7 x 1 SWITCHING MATRIX
COLUMN MEMORY & AUDIO
SWITCH. CIRCUIT DRG

DESIGN		DATE	
EXAMN			
WKS			
APP			
A2		9926

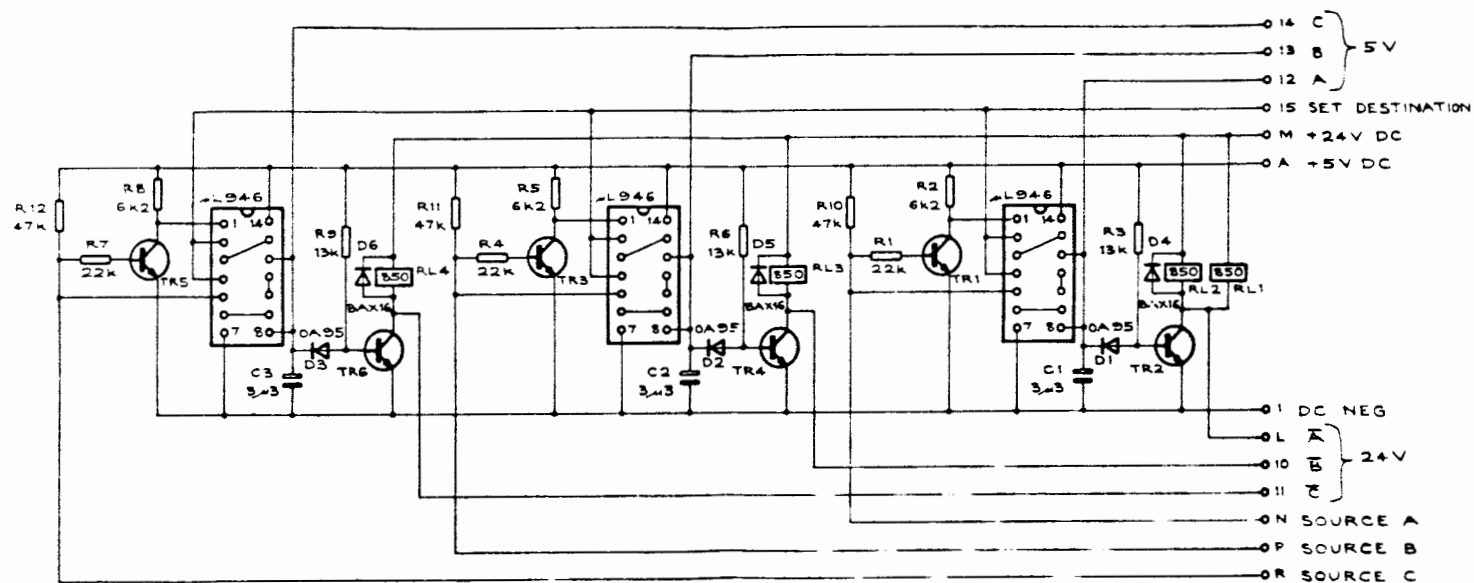
**DELETE C1-3
R2, 5, 8
now
680 ohm**
